GENERAL BUSINESS ZONE APPLICATION FOR PERMIT

Location 808 Congress Street Ward 5 Within Fire Limits? yes Dist. No. 1

In Reply, Please Refer To
C.87/489-1
Rept. 15130-1
R.S.-3-38

Your application for permit to alter roof sign on the building at
610 Congress St.

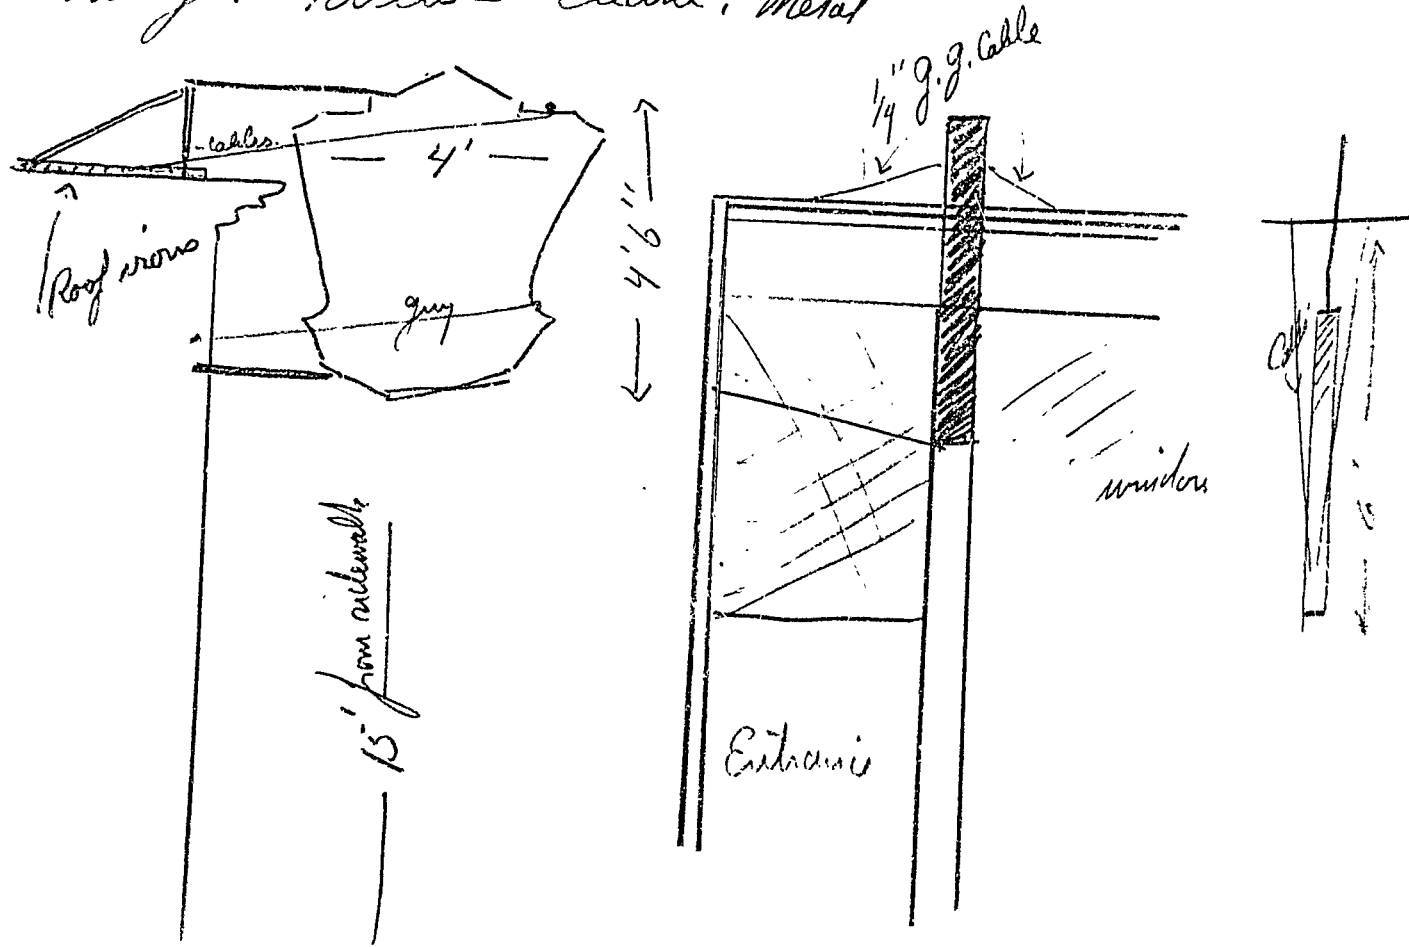
Work called for

Paragraph 3 of

attached specification

has not been done.

The electric restaurant

range does not have a

hood over it. There is

3/15/38. The lock has

put new lock on outside

door but it is not tight -

factory as it can be

locked inside. etc.

This lock has been

the catch removed

so it can not be

locked inside. Will

fix inside rear door.
